SPECIAL USE REPORT

► **FILE #:** 7-C-21-SU **AGENDA ITEM #:** 35
POSTPONEMENT(S): 7/8/2021 - 9/9/2021 **AGENDA DATE:** 10/14/2021
 ► **APPLICANT:** JOHN T. RUDOLPH
OWNER(S): UT Research Foundation

► **ZONING:** **I-RD (Research and Development) (C) / HP (Hillside Protection Overlay) / F (Floodplain Overlay)**
 ► **EXISTING LAND USE:** **P-QP (Public / Quasi Public Land)**
 ► **PROPOSED USE:** **Master Plan and Development Guidelines Amendment**

► **Approve the revisions to the master plan and development guidelines for the University of Tennessee Research Park at Cherokee Farm (FKA Cherokee Farm), subject to 7 conditions.**

Entrance Plazas

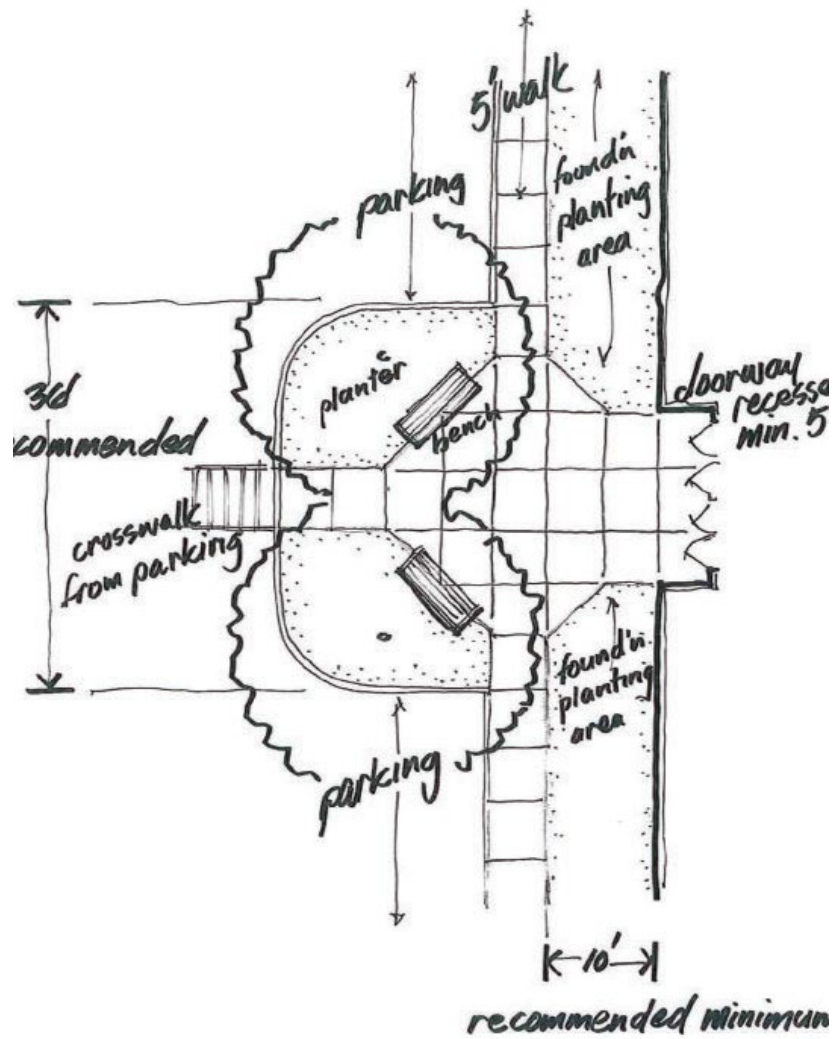
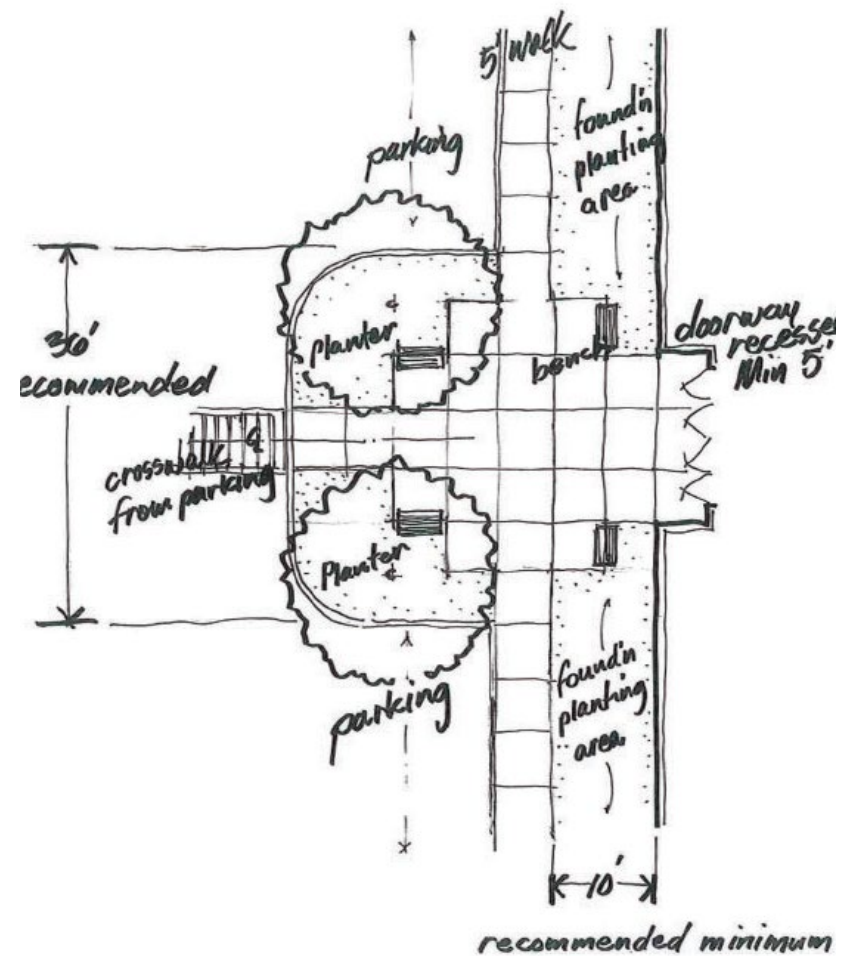
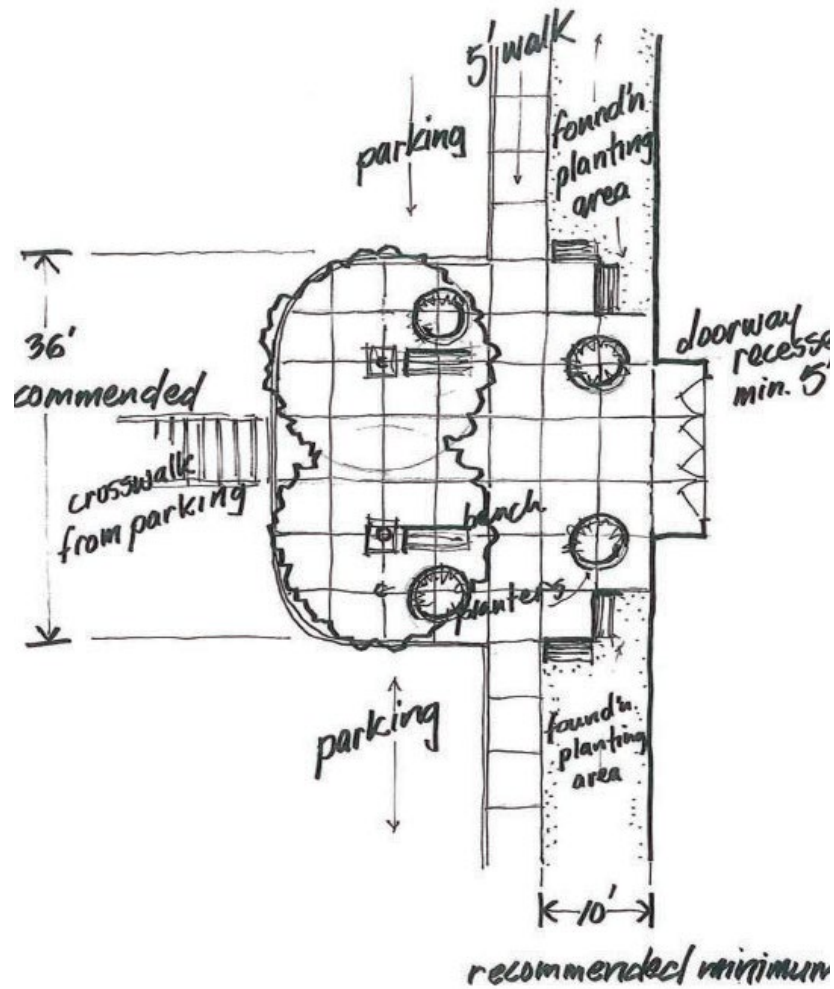
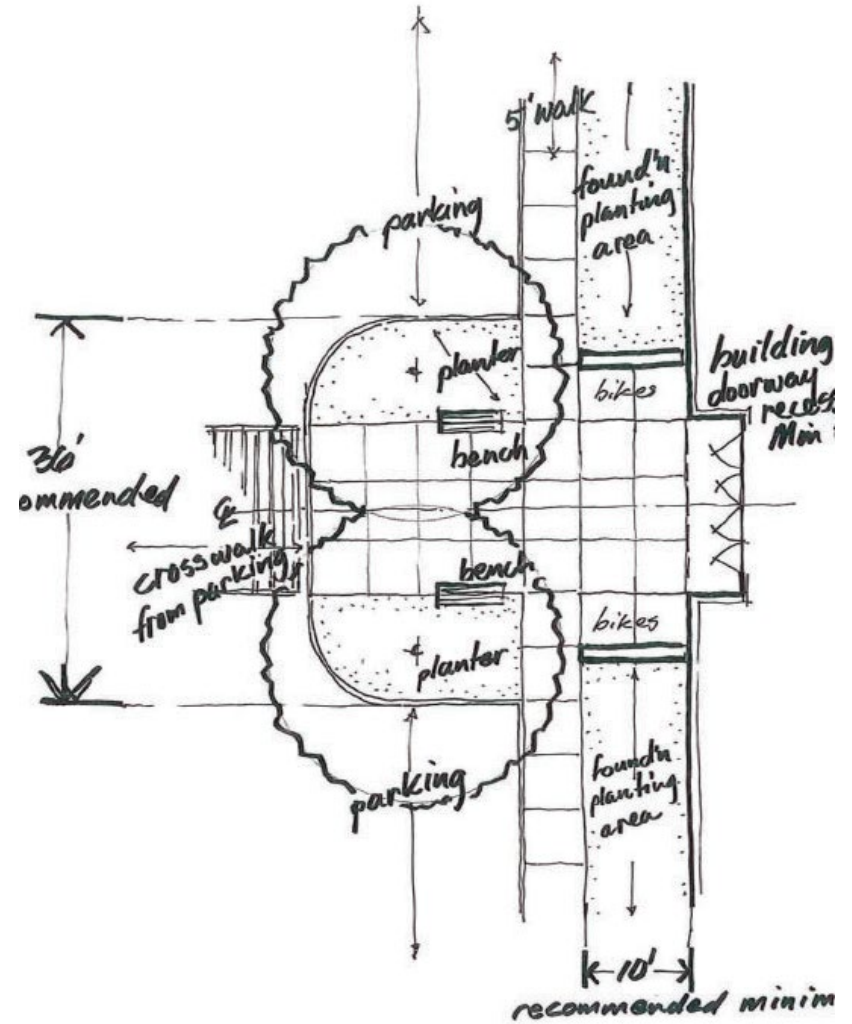
- 4) Delete an appendix that contains requirements for entrance plazas.
- 5) Revise the building height requirements to (1) use the City's zoning ordinance as the method to determine maximum allowable building height on each lot, and (2) acknowledge the height limits imposed by state scenic highway law, since the research park adjoins a section of Alcoa Highway that is designated as scenic.
